WORCESTER COUNTY TECHNICAL REVIEW COMMITTEE AGENDA

Wednesday, April 8, 2020

Technical Review Committee Conference Call Directions April 8, 2020 Meeting

Lot 8:

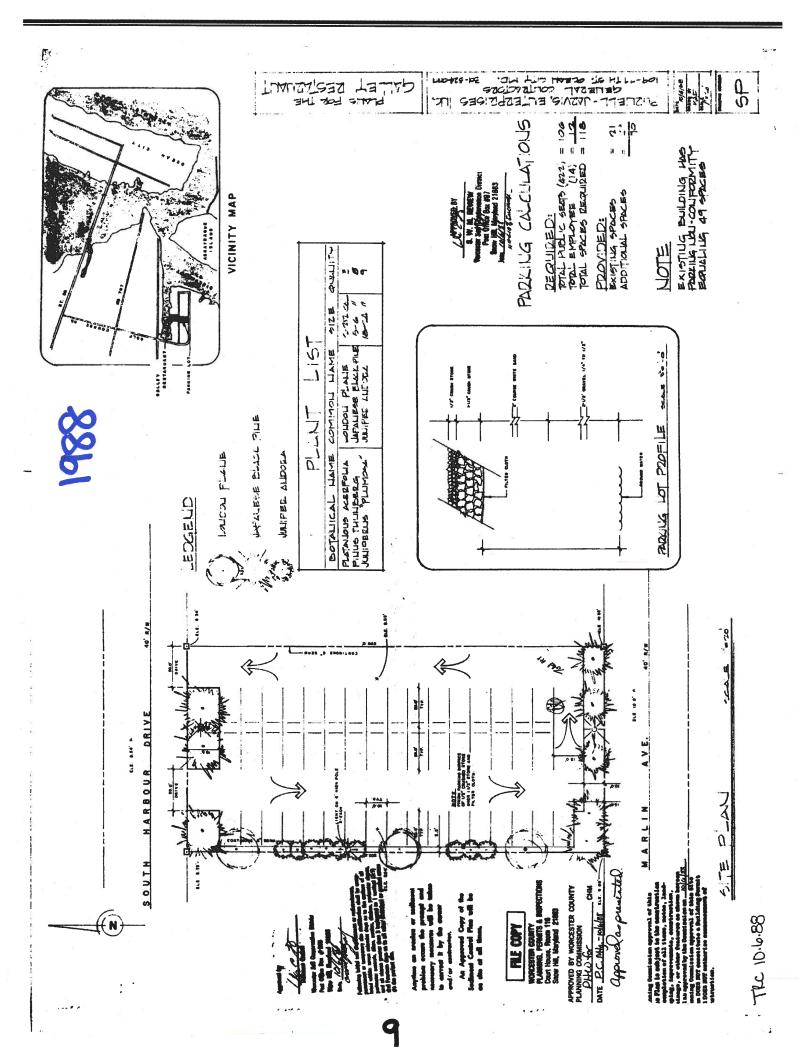
Parking on this lot was to be re-designed in 2011 per the attached plan. The parking shown does not match this plan, nor would it comply with the minimum requirements.

Our records show that Lots 7 & 8 are not owned by the applicant. It appears that Mr. Hanson (former owner of Captain's Galley) retained these lots in the original transfer. Therefore, we cannot establish parking on Lot 8 without additional approvals and agreements.

Motel lots:

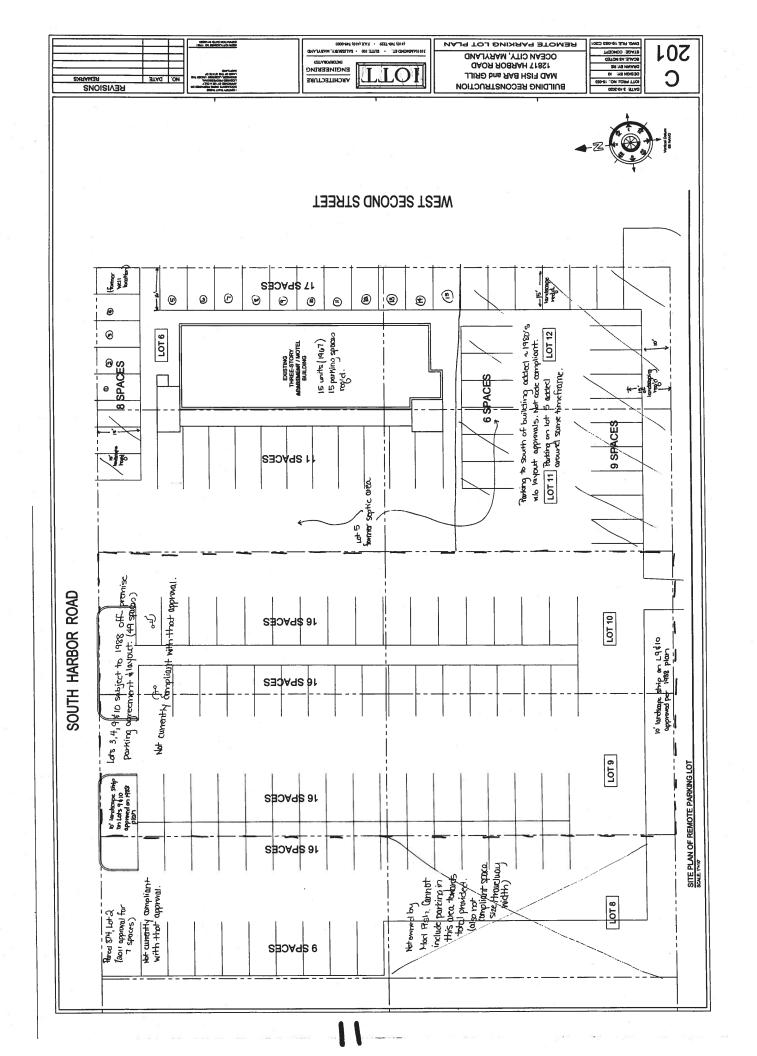
The approval for the motel originally consisted of 15 parking spaces on Lots 6, 11 and 12 as illustrated on the attached annotated sheet C201. The parking associated with that building was located on the north side of the building consisting of four (4) spaces with a well at the northeasterly property corner. Additionally, on the easterly side of the building facing West Second Street there were eleven (11) spaces extending to the southerly end of the building. Both parking areas had direct access onto the respective roadways. The remainder of the lots consisted of the septic tank and lines to the rear (south) of the building and the septic area was located on Lot 5.

It appears that the additional parking was installed sometime in the 1980's. The parking on the southerly end of Lots 11 and 12 are not currently code compliant with respect to space size and travelway width. Additionally, we cannot authorize additional parking to be provided that backs out onto West Second Street. The parking in this area will need to be re-designed to be code compliant. A code compliant handicap van accessible parking space will also need to be provided at the motel building if the parking lot is to be re-designed.
